Federal Register

[Docket No. FAA–2023–0668; Project Identifier AD–2023–00199–R; Amendment 39–22453; AD 2023–11–07]

#### Airworthiness Directives; Various Helicopters

**ACTION:** Final rule; request for comments.

Figure 1 to paragraph (g)(1)(i)—*Fundamental Effective Isotropic PSD at Outside Interface of Rotorcraft Antenna*

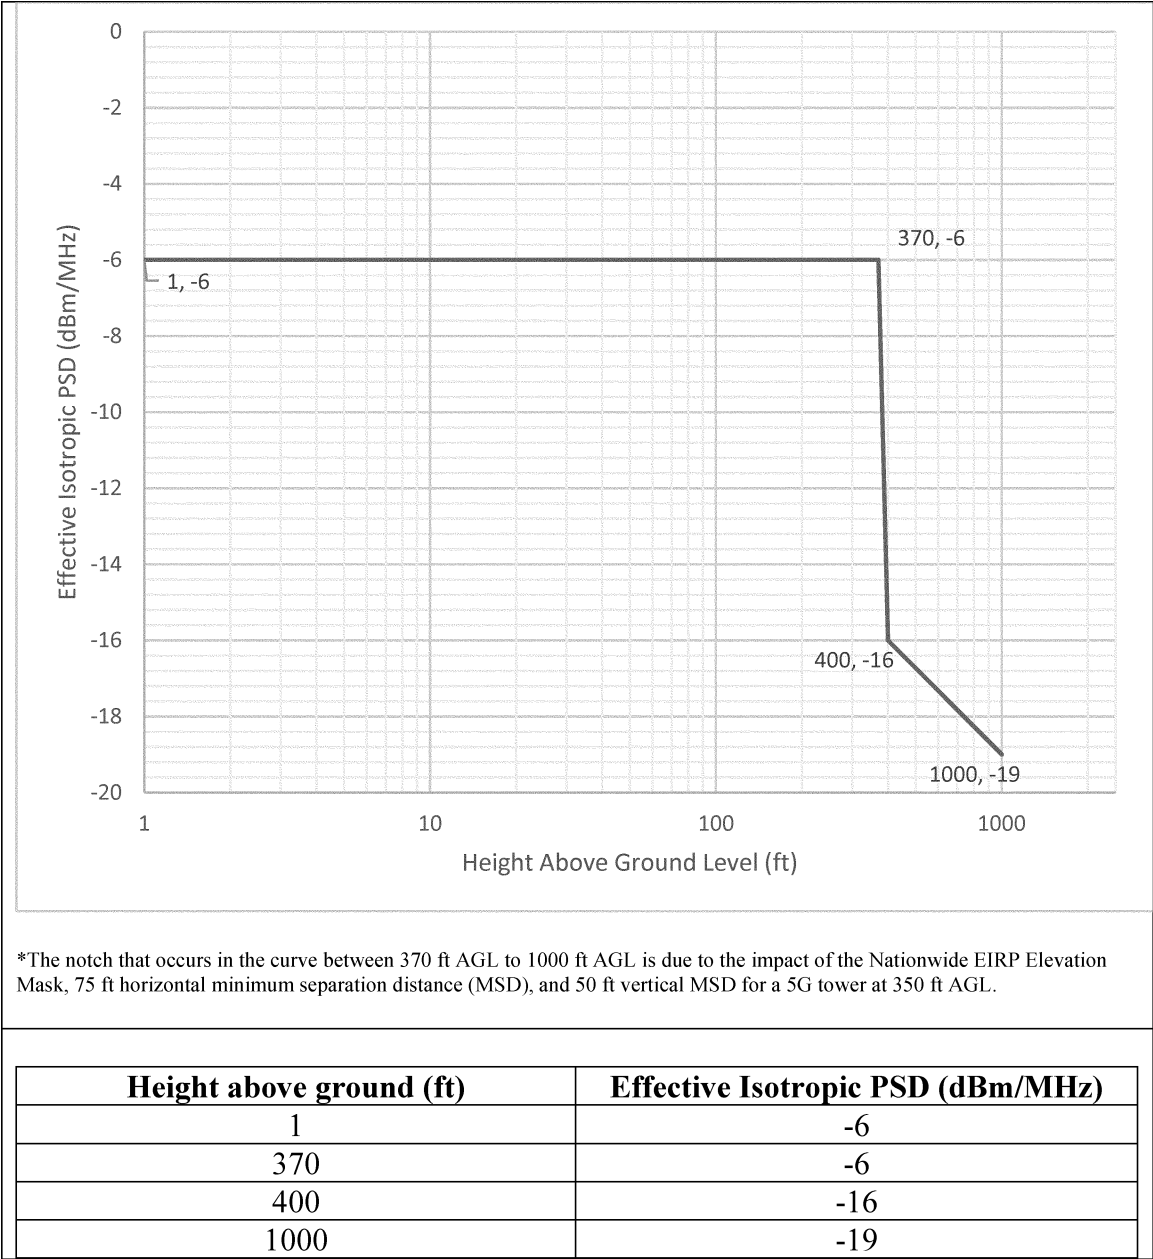
*Comment summary:* Thales and Sikorsky requested the FAA clarify several aspects of the PSD curve in figure 1 to paragraph (g)(1) of the proposed AD: whether no elevation mask is taken into account at and below 350 feet above ground level (AGL); at which base station emission power the PSD curve corresponds (62 dBm/MHz or 65 dBm/MHz); and whether the radio altimeter performance criteria in the curve explicitly covers any 5G emitter station up to 65dBm/MHz in the applicable 3.7–3.98 GHz band, for the foreseeable future. Sikorsky requested that the FAA revise the proposed AD to include a PSD curve that reflects the reduced EIRP levels for helicopters operating at the 188 priority airports (5G CMAs) with reduced power levels.

*Comment summary:* Sikorsky requested the FAA revise the PSD curve in figure 1 to paragraph (g)(1) of the proposed AD to change the height above ground at –6 dBm/MHz from 270 feet to 370 feet, and at –16 dBm/MHz from 300 feet to 400 feet. Sikorsky stated its request was based on several factors, including the minimum safe obstacle avoidance distance and the typical decision height used for radio altimeter

Sikorsky further stated that radio altimeters are not operationally used above 1000 feet, and therefore there is little value for any PSD restrictions above 1000 feet operationally.

*FAA response:* The notch in the PSD curve does not mean that no elevation mask is taken into account below 350 feet AGL. The elevation mask is taken into consideration below 350 feet AGL and is a fundamental consideration in how the PSD curve was established. The PSD curve was calibrated to cover 5G C-Band emitter stations up to 65 dBm/MHz in the applicable 3.7–3.98 GHz band.

*FAA response:* The FAA assumed an emitter base station height of 350 feet based on consensus reached in rotorcraft industry group meetings. Additionally, FAA analysis of existing emitter base station height data shows that, while higher emitters do exist, they are infrequently adjacent to helipads. Second, the FAA assumed the rotorcraft was no closer than 50 feet above and 75 feet laterally from the emitter. The vertical distance was based on pilot feedback and the lateral distance was based on common lateral separation from the main rotor tip recommendations of 2 main rotor diameters from the tip of the rotor, selecting a 30 foot rotor as the smallest rotor in this class of aircraft with the antenna under the main rotor mast. An operator of an individual model rotorcraft with a larger rotor diameter may request approval of an AMOC to the AD on the basis of separation distance. Third, the FAA assumed that the emitter was active at the full rural power level of 65 dBm/MHz allowed in FCC Report and Order FCC 20–22.<sup>2</sup> The FAA then evaluated the resulting curve against data from radio altimeters and found it to be achievable with current technology using filters that have been developed. Based on data from existing emitters, if the height reduction from 370 feet to 270 feet, as requested by the commenter, were adopted, it would result in many more landing scenarios unprotected from interference because emitters on towers at about 250 feet as opposed to the accepted assumption of 350 feet are much more common. For this reason, the FAA did not adopt this request.

The FAA has re-evaluated the need for PSD performance requirements above 1000 feet and agrees with the reasons provided by the commenter. The PSD curves specified in this AD have been changed accordingly.

Figure 2 to paragraph (g)(1)(ii): *Spurious Effective Isotropic PSD at Outside Interface of Rotorcraft Antenna*

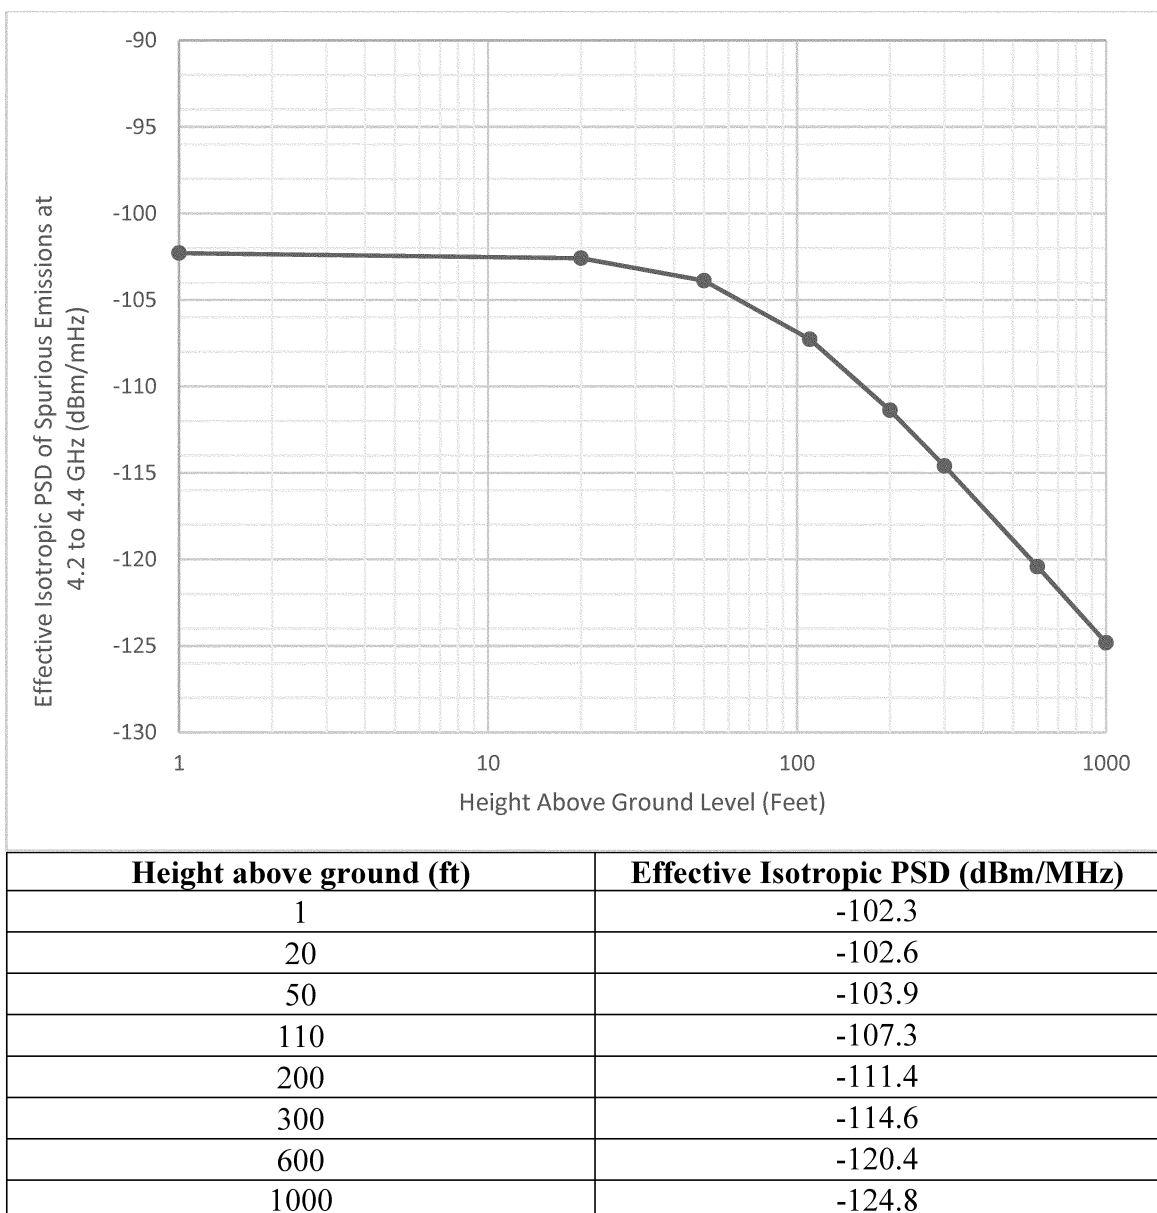
*Comment summary:* HAI, Sikorsky, and Thales requested that the FAA revise the proposed AD to include the frequency range to which the PSD tolerance curve thresholds apply, a new figure indicating the spurious tolerance similar to the figure with the PSD tolerance curve, and a specification of the altitude dependence for spurious tolerance.

The FAA invites you to send any written data, views, or arguments about the spurious emissions PSD tolerance curve as specified in figure 2 to paragraph (g)(1)(ii) of this final rule. Send your comments to an address listed under **ADDRESSES**. Include “Docket No. FAA–2023–0668 and Project Identifier AD–2023–00199–T” at the beginning of your comments. The most helpful comments reference a specific portion of the figure, explain the reason for any recommended change, and include supporting data. The FAA will consider all comments received by the closing date and may amend this final rule because of those comments.

In this final rule, the FAA replaced the proposed fixed aggregate spurious emission level of –42 dBm/MHz (conducted) with a spurious PSD tolerance curve for 5G C-Band interference from a single base station. This form of the requirement is consistent with the transport and commuter category airplane

requirement. Similarly, it does not include an aggregation factor or any base station or aircraft antenna gain factors. The spurious PSD tolerance curve is based on a different spurious emission level than what the FAA proposed in the NPRM (−30 dBm/MHz conducted for a single indoor base station instead of −48 dBm/MHz conducted for a single outdoor base station and an aggregation factor of 6 dB which yielded an effective aggregate level of −42 dBm/MHz).

*FAA response:* The FAA agrees and has added the frequency range to the PSD tolerance curve. Additionally, as explained previously under "Actions Since the NPRM Was Issued," the FAA has replaced the proposed fixed emission level with a spurious PSD tolerance curve.
